No.: 05 TS – 40Rev2
November 22, 2006

SUBJECT: **MBE 4000 EGR Temperature Sensor**

Figure 1 EGR Temperature Sensor

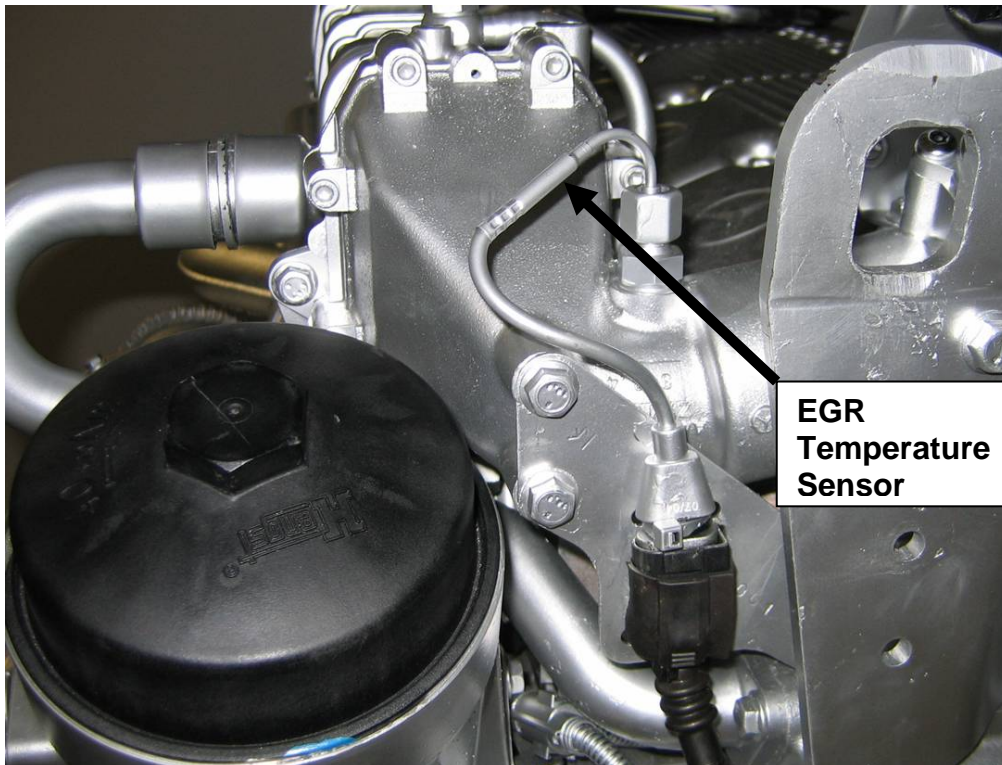
Broken tips on the EGR temperature sensor

The broken tip can cause downstream internal damage to the engine. See (Figure 1).

If the EGR Temperature Sensor fails, do not install another sensor. Remove the sensor, install a plug in the pipe and in the electrical harness, and re-flash the PLD with a new fuel map to turn off the sensor.

Figure 2 Re-Flashing PLD

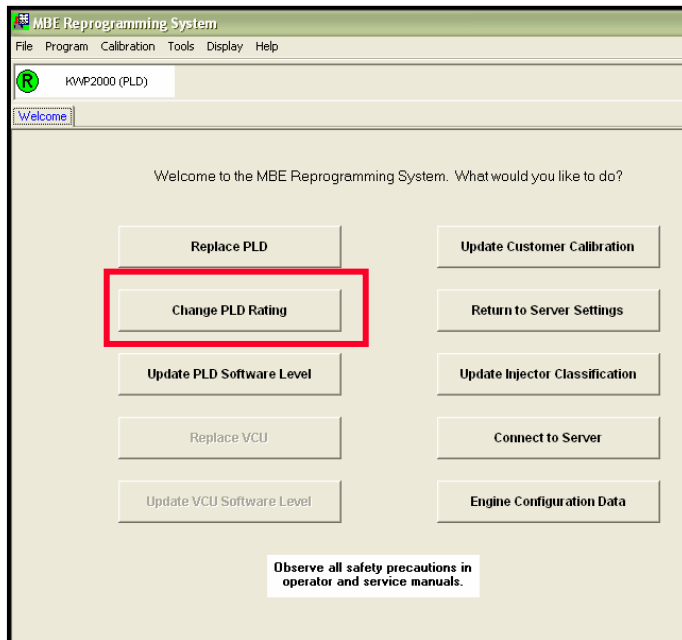
1. Confirm the sensor is at fault by following the troubleshooting steps for SID 146 in the *MBE 900/4000 EGR Technicians Guide (7SE940)*.
2. Unplug the EGR Temperature Sensor from the electrical harness and remove the sensor from the adaptor in the pipe.
3. Install cap on the adaptor. Torque cap to 32 Nm (24 lb-ft).
4. Install plug in the electrical harness and tie strap the harness securely in place to prevent it from moving and possibly be caught in other moving parts.
5. Re-flash the PLD with new fuel map to turn off the sensor. Select “Change PLD Rating” in the MBE Reprogramming System (refer to figure 2 below).

6. View the EGR temperature on Detroit Diesel Diagnostic Link (DDDL). No temperature will be displayed if the sensor has been successfully turned off.
7. Start and run the engine and confirm the sensor has successfully been turned off and no codes are logged.
